## **REMARKS**

### **Objections to the Drawings**

### **In the Drawings**

FIG. 1 - Prior Art

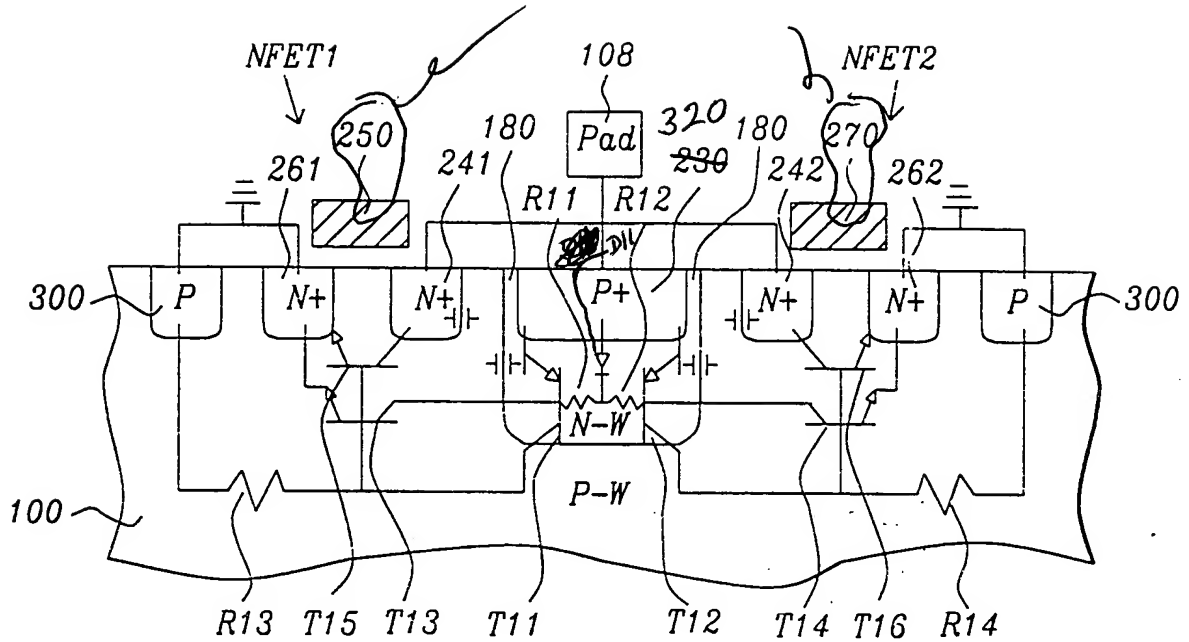
The Office Action objects to the drawings due to various informalities. Specifically, several reference characters used in the drawings were not mentioned in the specification and *vice versa*. In this regard, Applicants have provided replacement drawing sheets to be entered and has amended the specification as indicated above. Applicants respectfully assert that no new matter has been added. Specifically, Applicants have:

removed reference characters 250 and 270 in the amended Fig. 1;

replaced reference character 230 with reference character 320 such that the drawing is consistent with the description;

added reference character D11 to designate the diode in Fig. 1;

FIG. 2

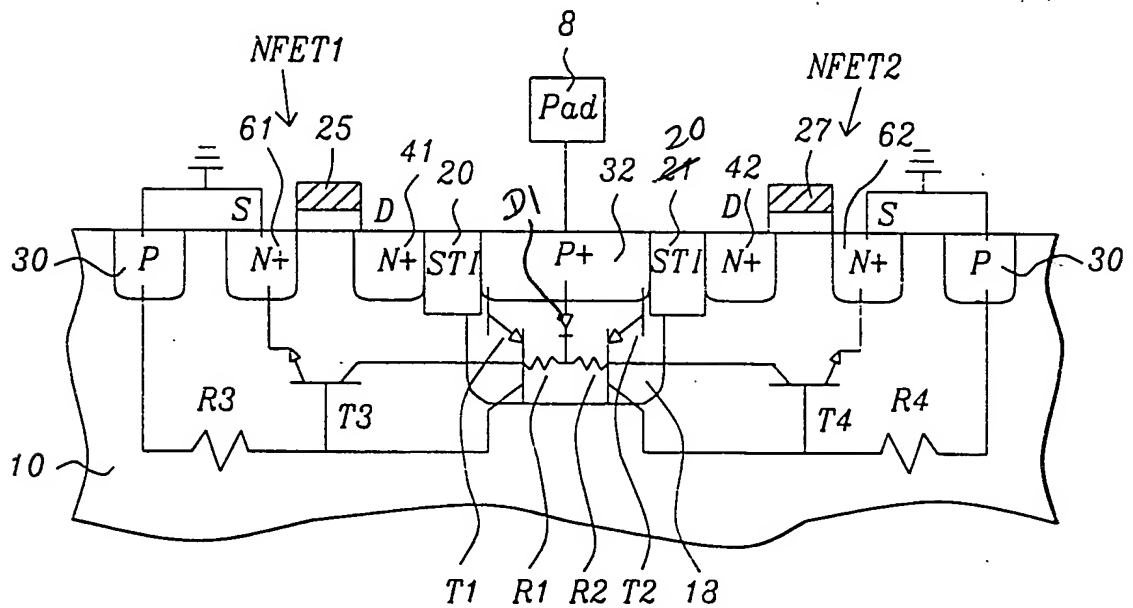
replaced reference character 21 with reference character 20 in the amended Fig. 2;

added reference character D1 to designate the diode formed with the anode being the P+ contact regions 32 and the cathode being the N-well 18;

FIG. 4

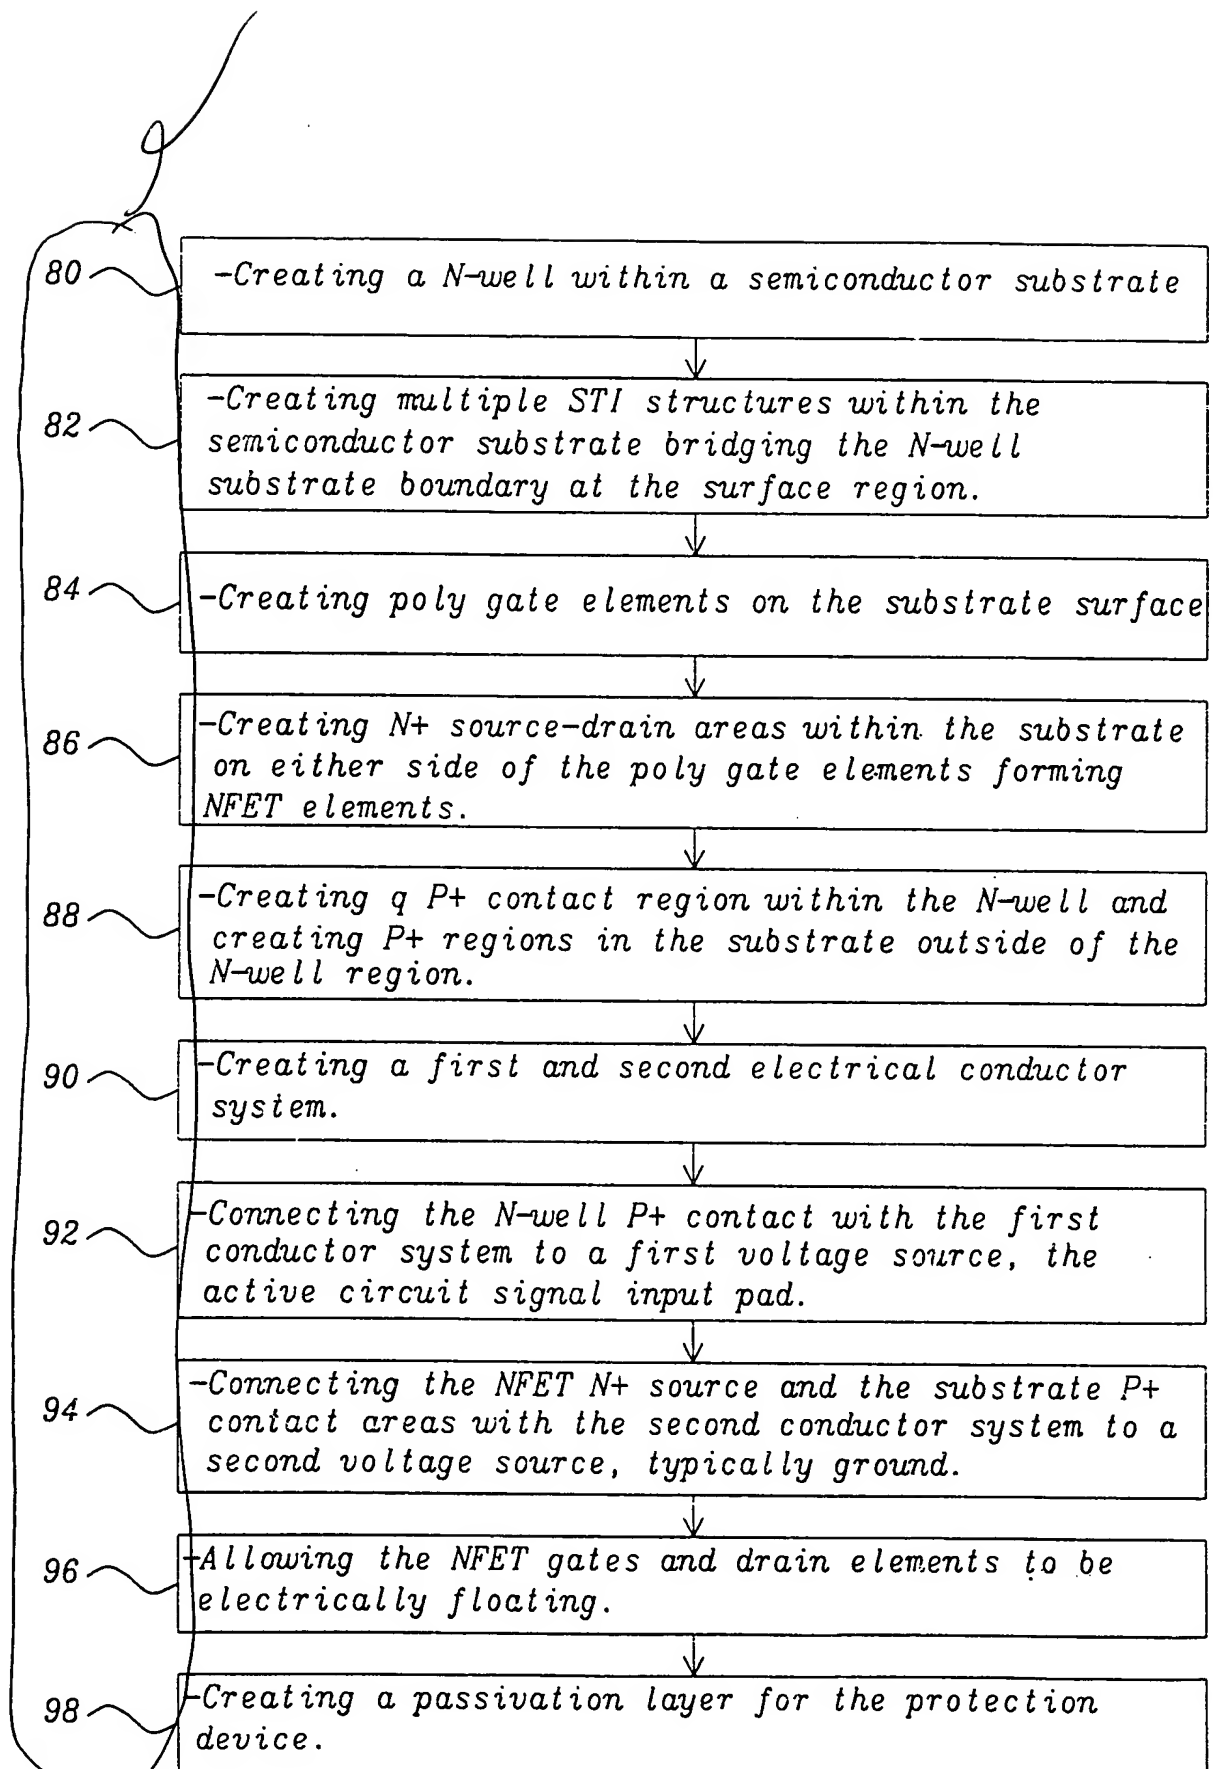
removed reference characters 80, 82, 84, 86, 88, 90, 92, 94, 96, and 98 from Fig. 4 since these reference characters are not mentioned in description; and

FIG. 5D

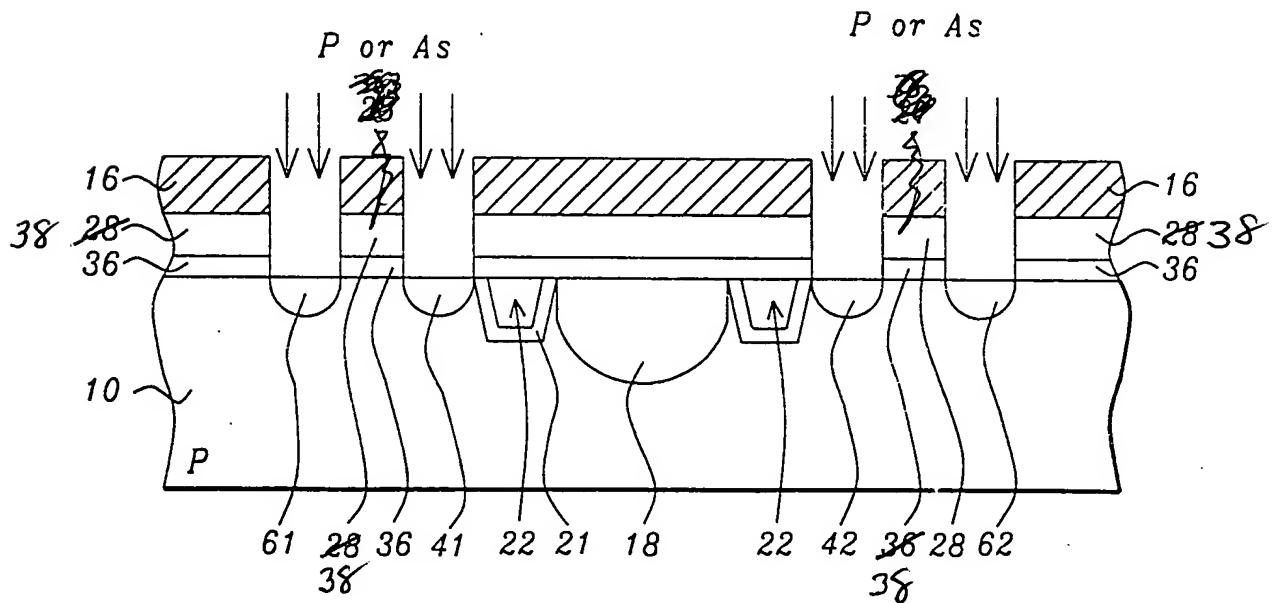
replaced reference character 28 with reference character 38 in the amended Figs. 5D and 5E.
